City of Oakley

ADDENDUM NO. 1 to contract documents for
LAUREL ROAD WIDENING PROJECT, CIP # 196

BID OPENING DATE: November 20th, 2018 2:00 PM

Date: 10/19/2017	Revisions
Scale: AS NOTED	20181019 ADDENDUM No. 1
Design: CC	
Drawn: AH	
Approved: MC	
Job No: 2017095-10	
Drawing Number:	S-1
	11 OF 58

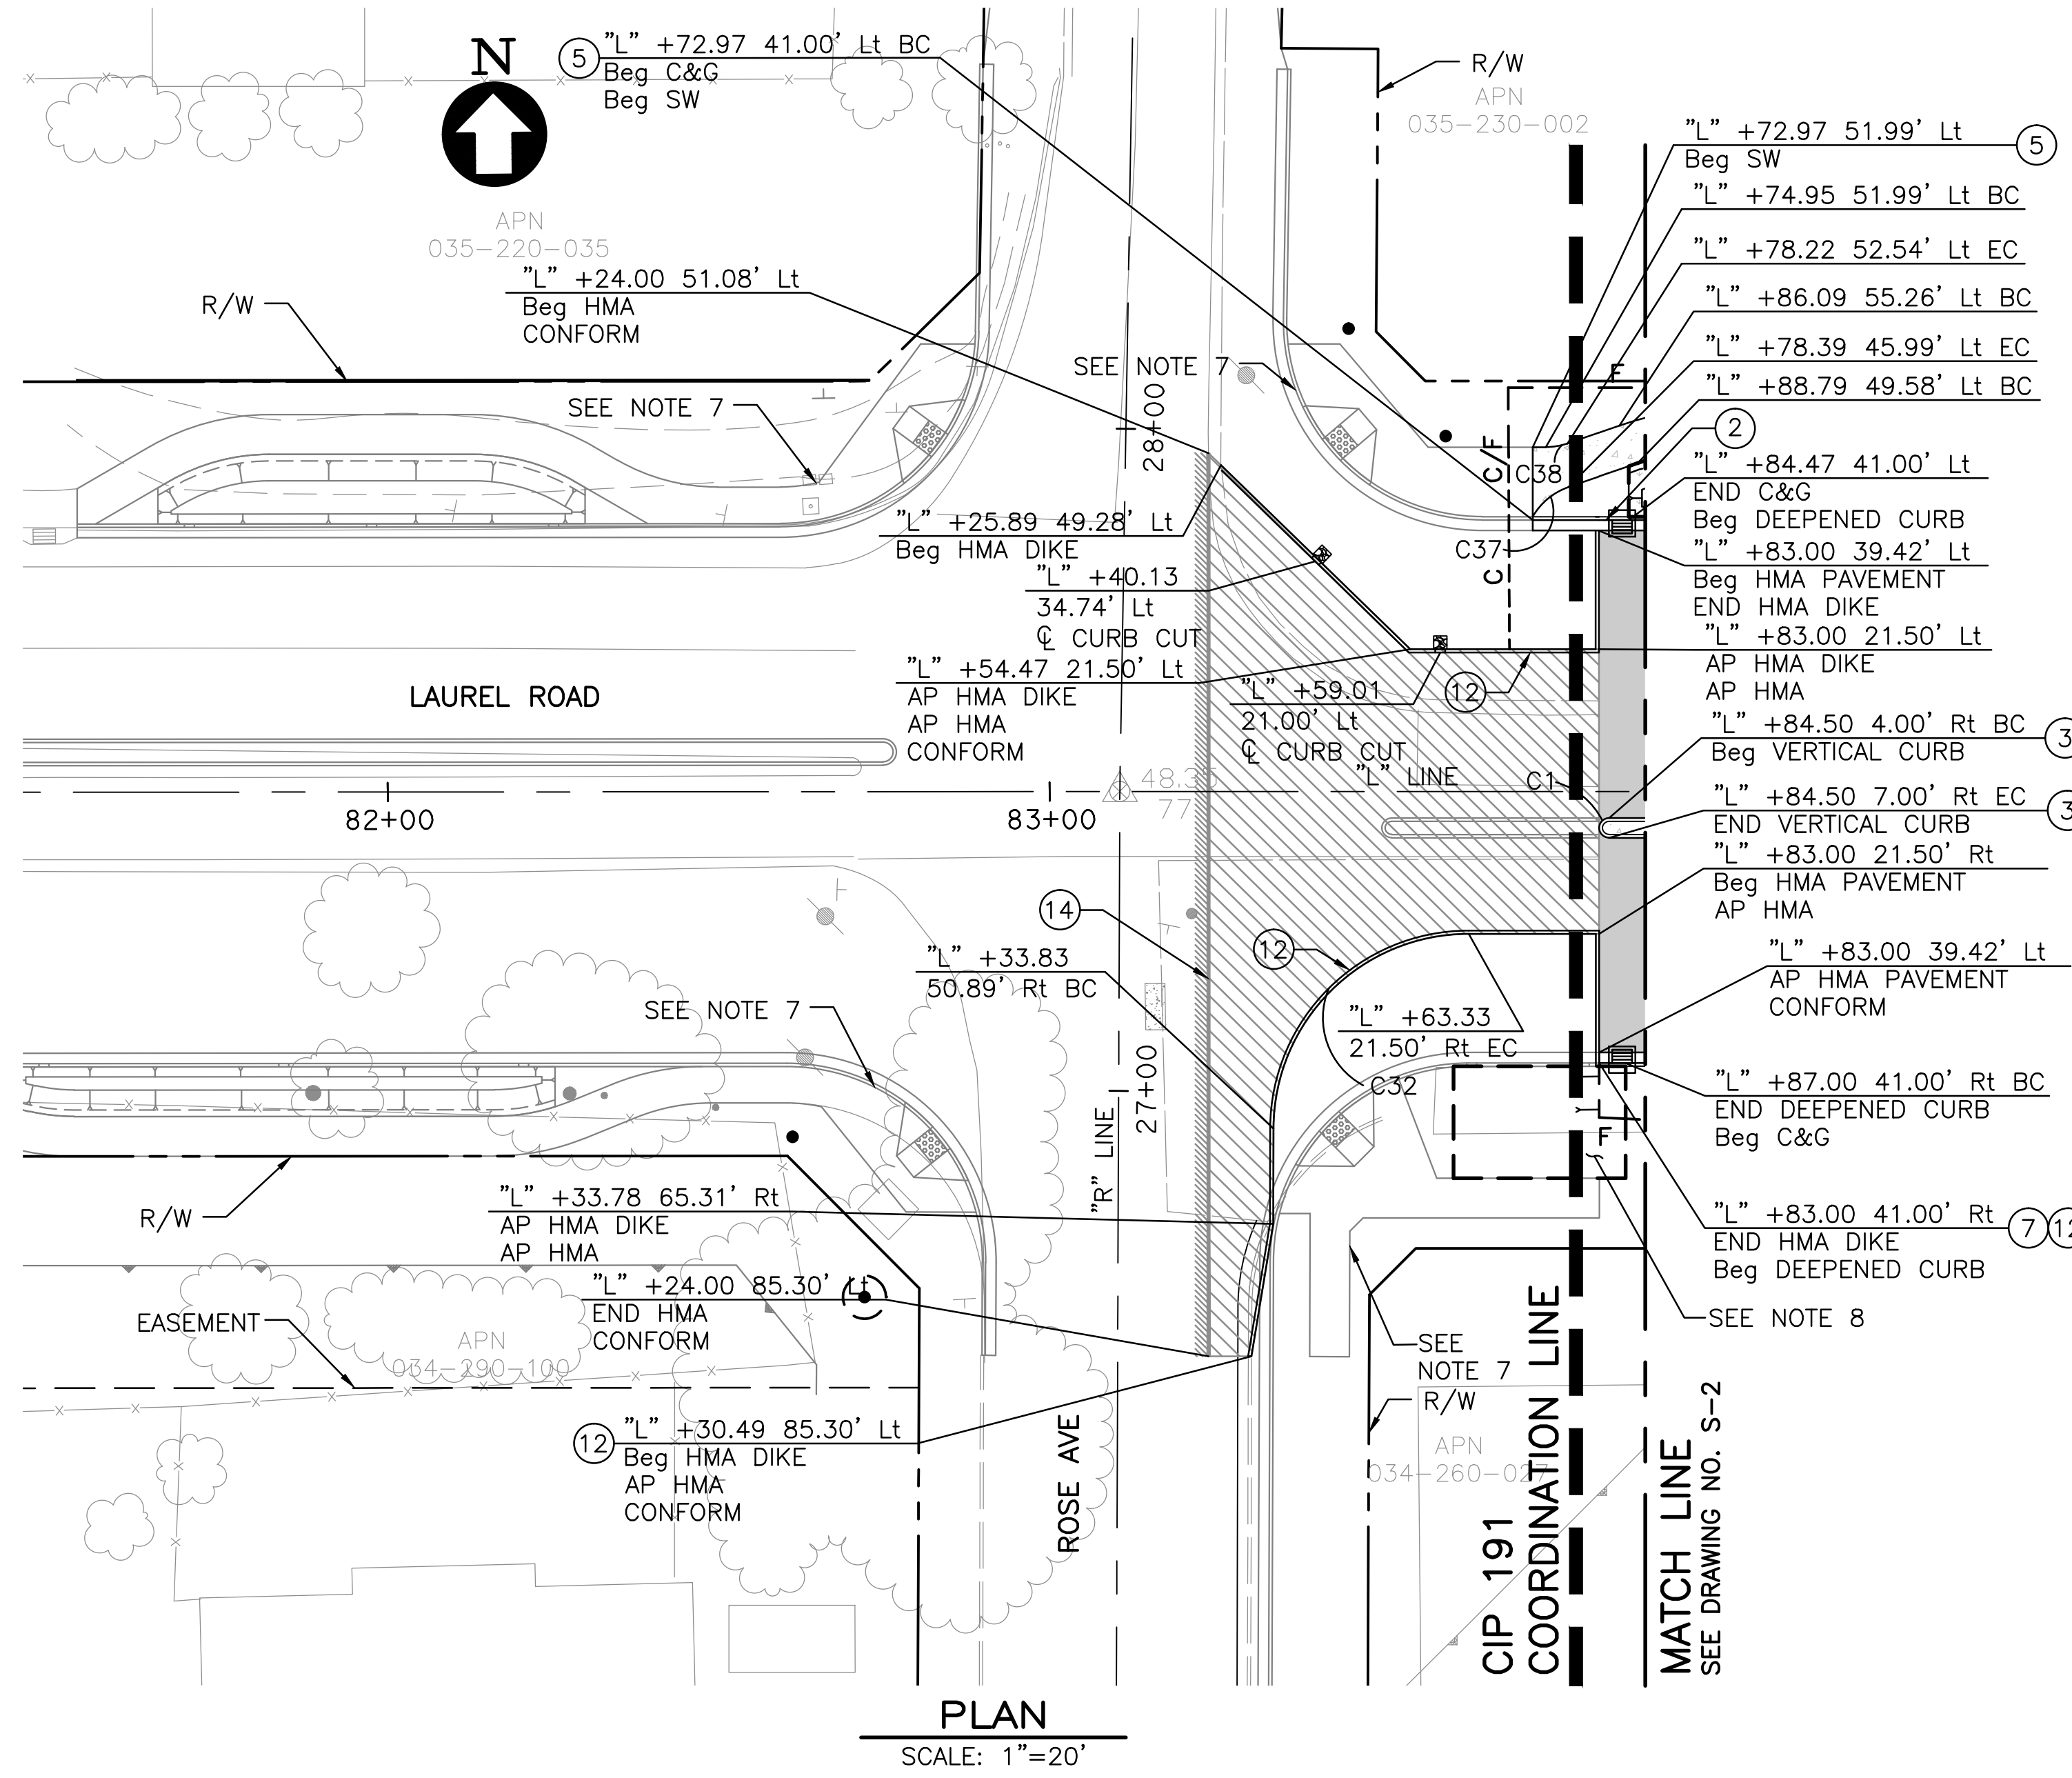
- Updated Sheets DM-4, S-1 to S-4, CD-5, GD-4 and U-2
